WEST HAVEN CITY
PLANNING COMMISSION AGENDA

MEETING TO BE HELD
December 14 6:00 PM
City Council Chambers
4150 South 3900 West, West Haven, UT 84401

Planning Commission
Staff Review Memo

PRELIMINARY SITE PLAN APPROVAL

SITE PLAN

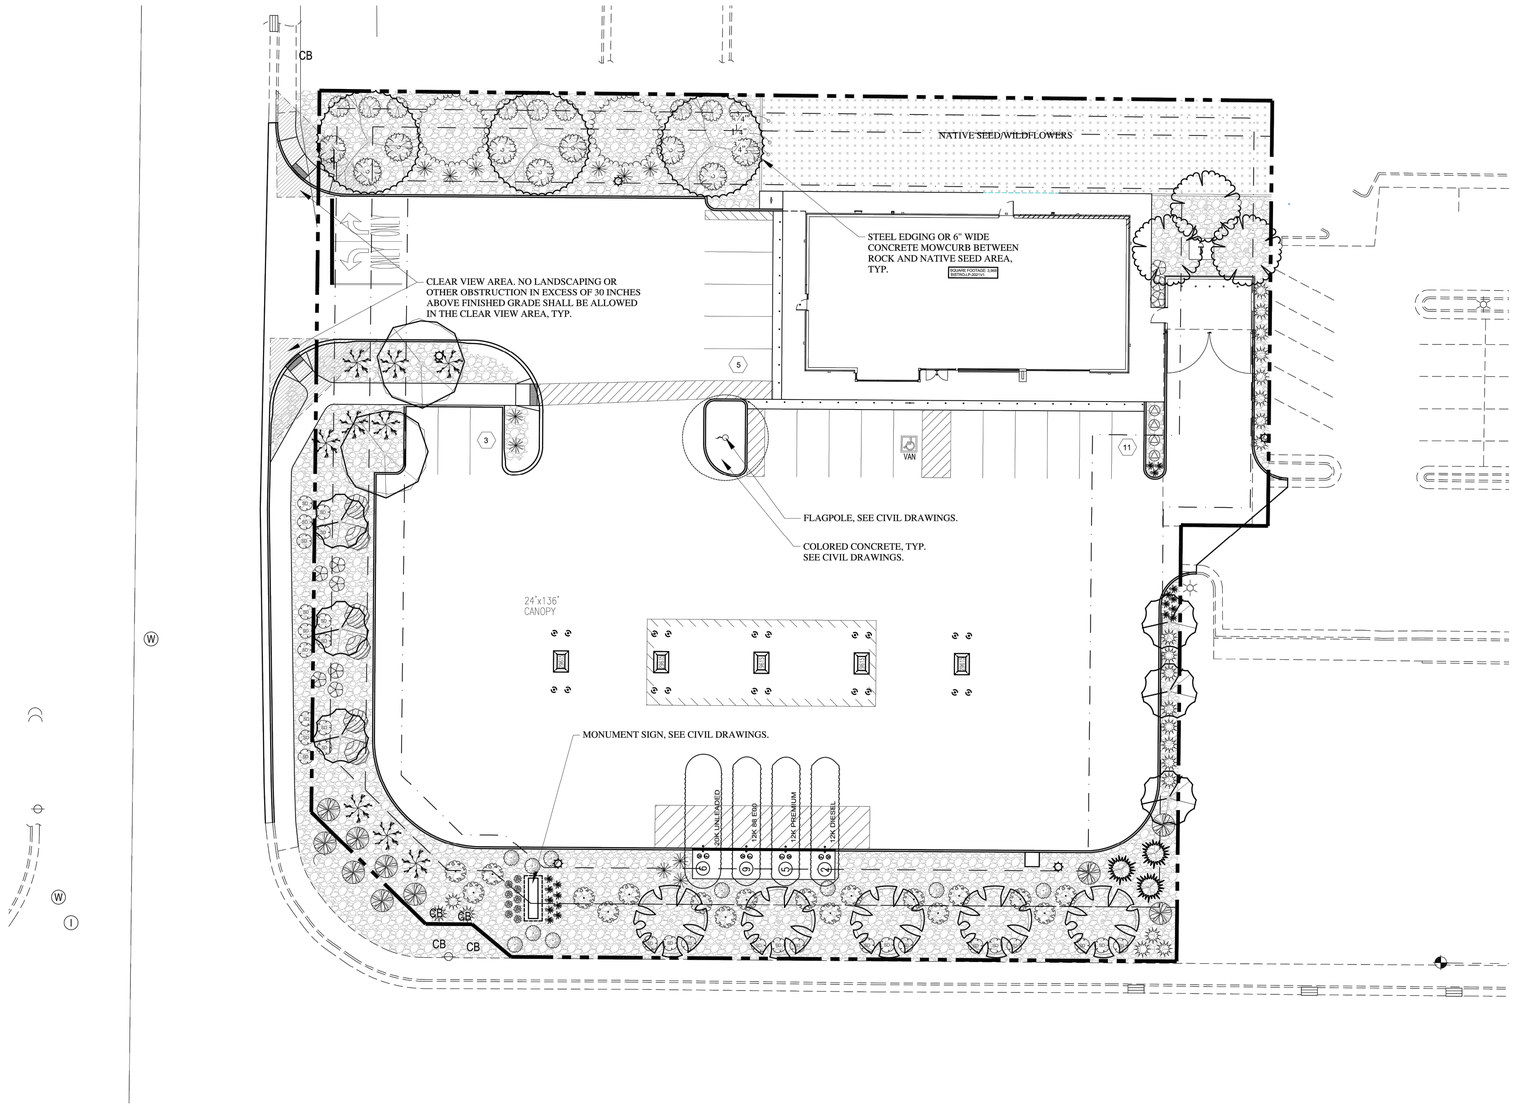
The closest use that is specified is a retail store, which requires 1 space per 200 square feet of floor space in the building. This standard would require 19 parking spaces on the site. ***The site plan proposes 19 total parking spaces. This satisfies the requirement and intent of the parking regulations.***

(1) Does the site plan comply with the West Haven City Engineering Design Standards and Specifications related to traffic ingress, egress and internal circulation? ***At the preliminary level, the site plan complies. There is no access proposed on to 4000 South, so no coordination with UDOT is required. As the final civil documents are prepared, the applicant will be required to make any minor modifications necessary to ensure the site is consistent with City standards.***

(a) Front yard. Landscaping shall be required along the entire frontage of the lot, except for the frontage required for ingress/egress. Said landscaping shall be a minimum of 15 feet deep, calculated from the property line. ***Because the building faces 4000 South, that is considered the front yard. As shown on the site plan (p 2/12) and the landscaping plan (p 5/12), there is 30.6' of landscaping along 4000 South, satisfying this requirement.***

- **Prior to final approval, the applicant shall provide the City with the following:**
    - **A will-serve letter from the Hooper Water Improvement District**
    - **Finalized elevations showing the distribution of architectural materials across the building to ensure compliance with the design criteria.**

PRELIMINARY LANDSCAPE PLAN

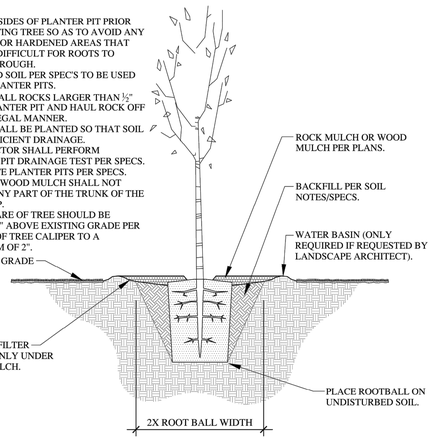
Page 5/12 (landscaping plan) provides that the project will have trees, decorate rock and boulders, shrubs and grasses. This requirement has been satisfied.

South Elevation
NTS

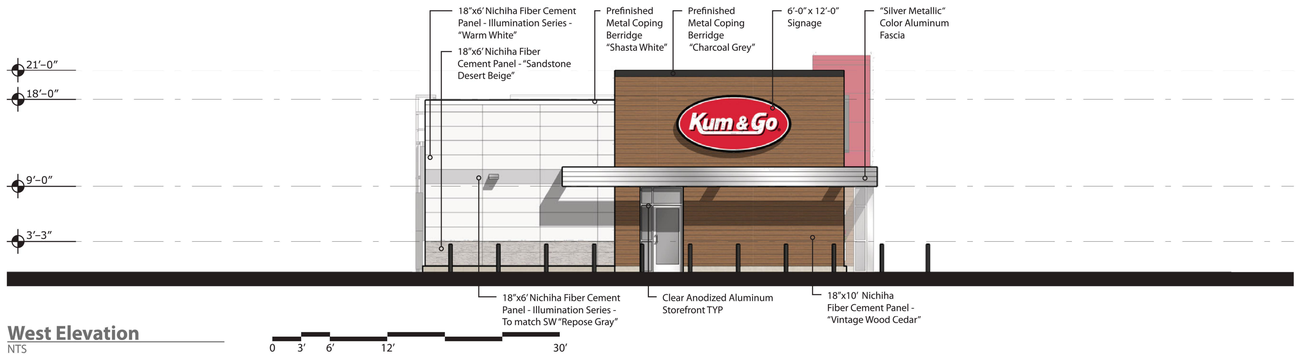
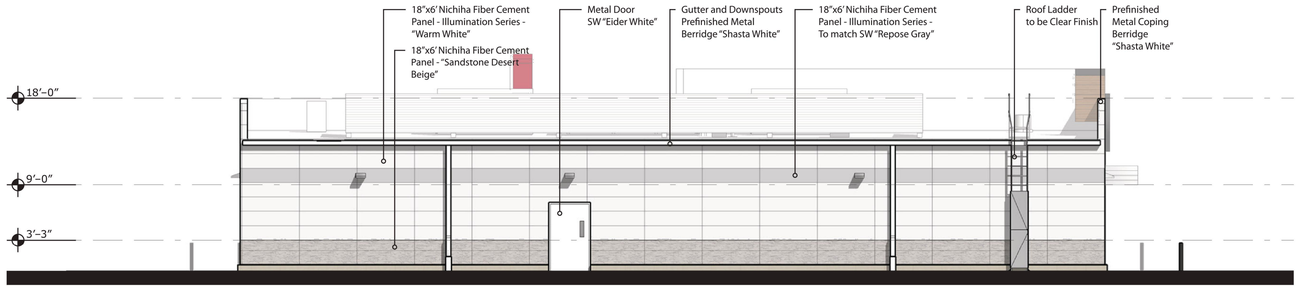
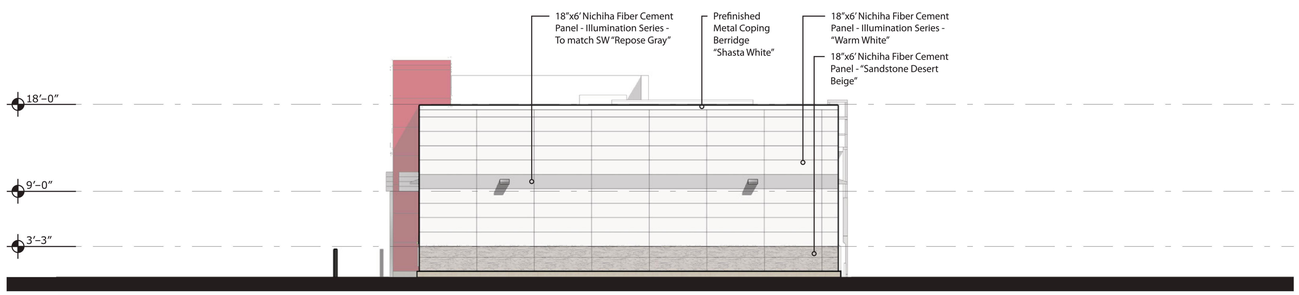
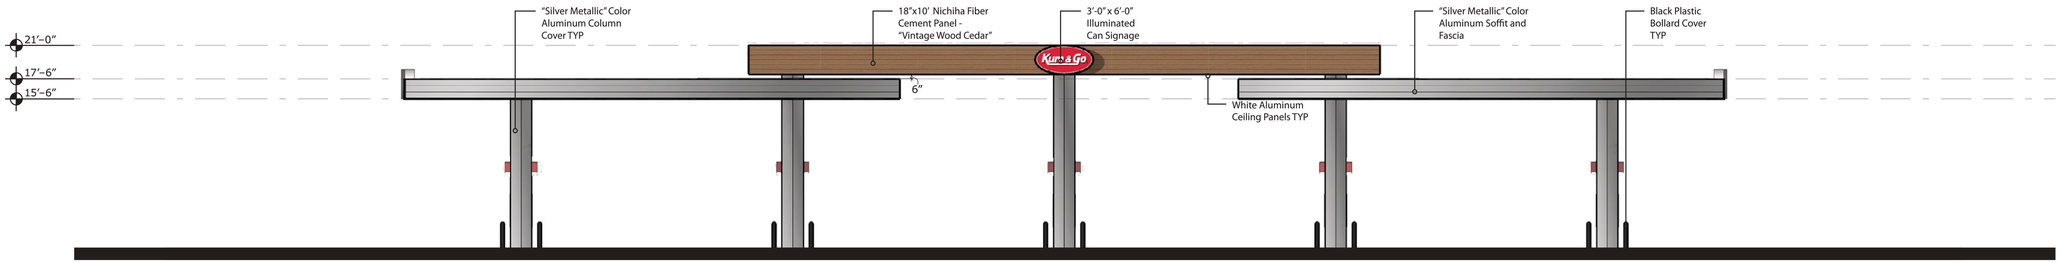
(1) All buildings shall be designed with breaks in the facade. This may be accomplished through a change in building materials, actual breaks in the facade, a mix of roofline projections. ***There are breaks in the façade of the proposed building. The breaks are accomplished by several things- projections, varying building heights, change in materials, inclusion of windows. This requirement has been satisfied.***

B 8' MONUMENT SIGN
NOT TO SCALE

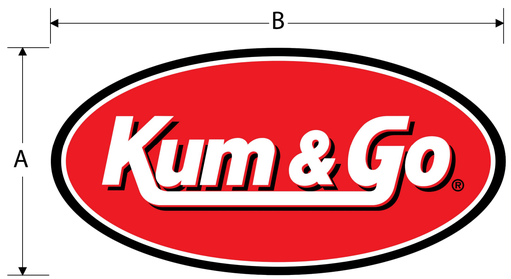
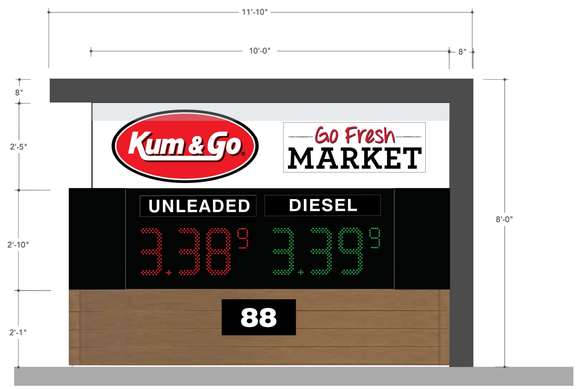
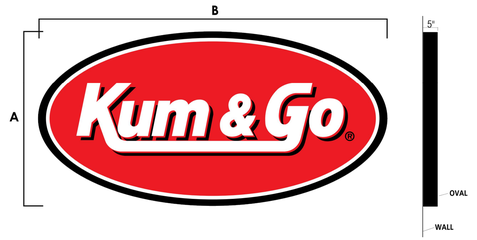
Because this is a standalone project rather than part of a commercial complex, it is a considered a "freestanding commercial" monument sign. The monument sign regulations for such are as follows (see sheet 11/12 of submittal docs for proposed sign design):

300-599 Linear Ft. Frontage	Requirement	Site Plan Proposal	Compliant
Max. area per sign face	65'	64'	Y
Max Height	8'	8'	Y
Max # of Signs	1	1	Y

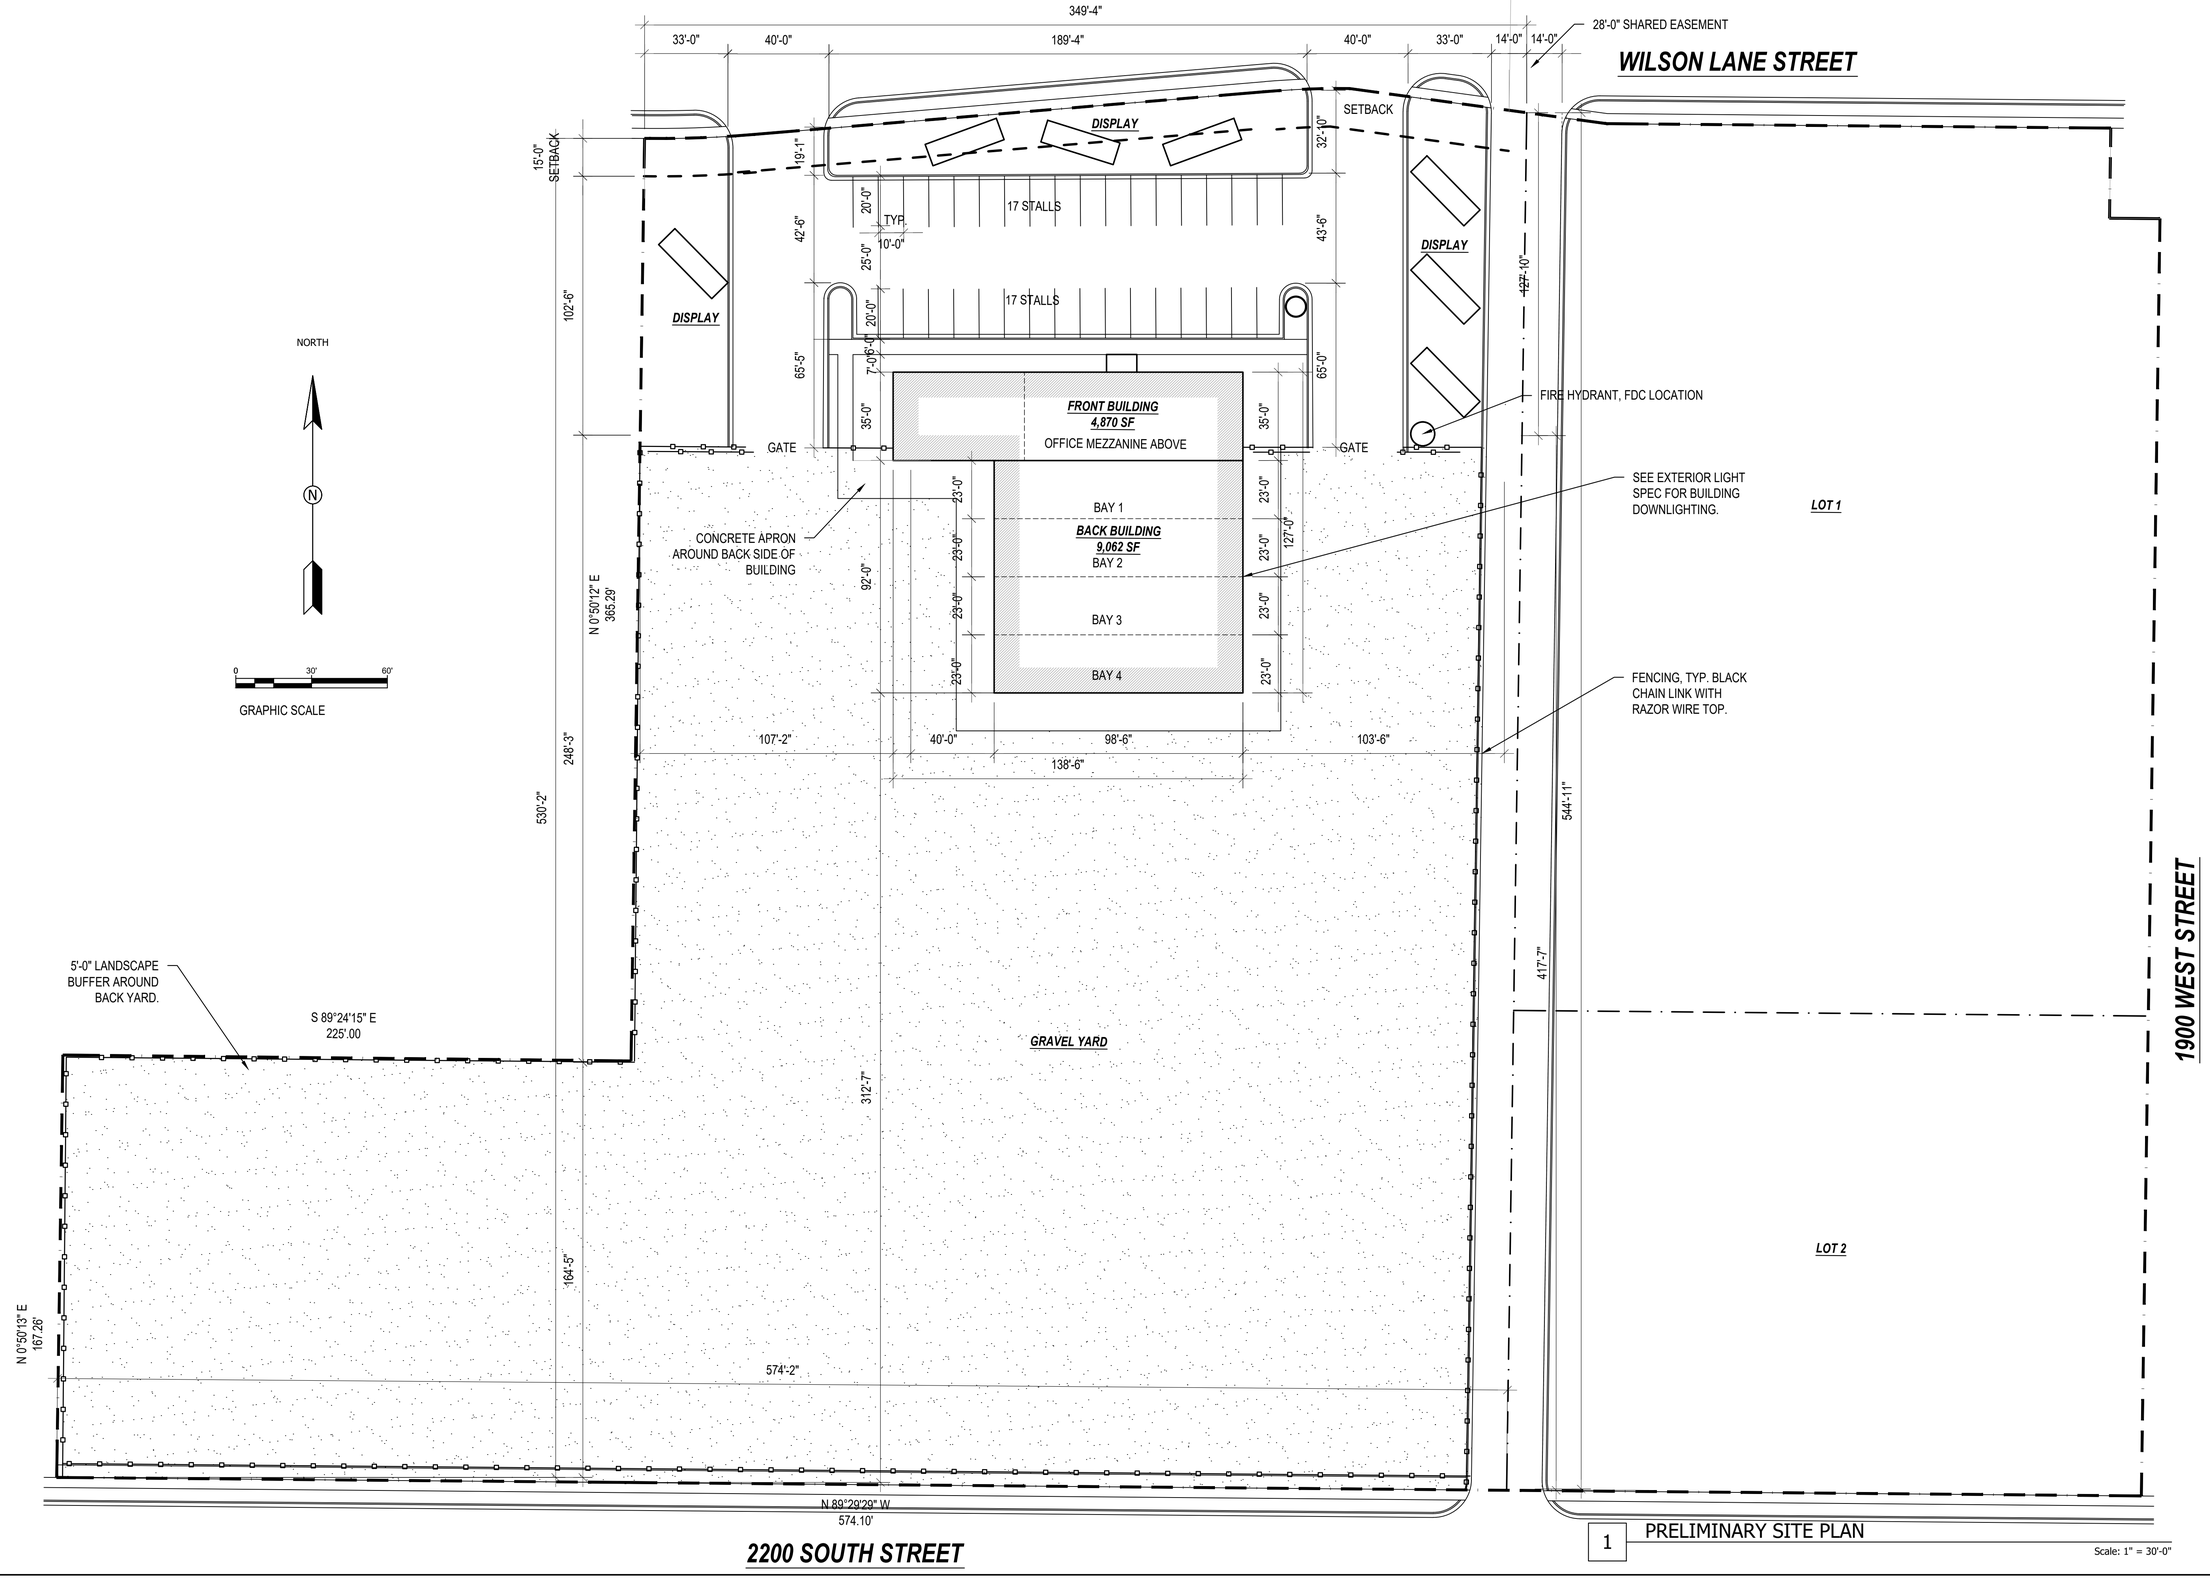
1- They do not have an approved set of civil drawings
   a. These are in the process of being reviewed. The applicant has been made aware that no permits for site improvements will be issued until the City Engineer has approved and stamped the civil drawings.
2- The sign that they are proposing (a pole sign) is not a permitted sign type in the C-2 zone. There are pole signs in various C-2 zones throughout the City, but pole signs were omitted (inadvertently, I believe) when the City redid its sign code in 2021.

a. John Deere requires Honnen to have JD specific signs, as part of JD's branding. Regardless of the commercial zone that Honnen is in, JD dictates the signage they need to have.
